### **AGENDA**

Tuesday, January 19, 2021 - 4:00 P.M. https://tinyurl.com/sbplancommission

Subdivision Name: ST. ANTHONY'S MINOR SUBDIVISION

Location: This Minor Primary subdivision is located at the southwest corner of Ironwood

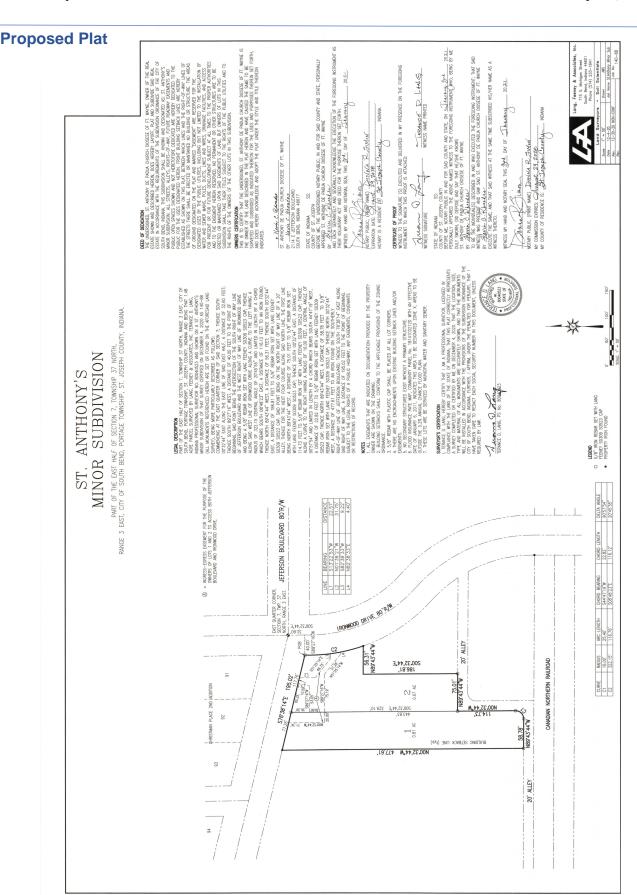
**Agency Comments:** Engineering noted that the adjacent sidewalks are in need of

**Staff Comments:** The existing deck on Lot 2 crosses the rear lot line into a property not included in the plat. Because the lot line is an existing lot line, the staff cannot require the adjacent property be included in this plat. An encroachment note should be added to allow this to be known during any title research. The staff also notes that the structure on Lot 1 shall only be used for uses allowed within the appropriate zoning district.

**Staff Recommendation:** The Staff has reviewed this subdivision and finds that if the conditions are met it complies with the requirements for Approval as specified by the South Bend Subdivision Control Ordinance. The Staff therefore recommends that this subdivision be granted Approval, subject to the following: 1) Modifying the encroachment note to state: The existing deck on Lot 2 encroaches into an adjacent parcel not included in the plat.
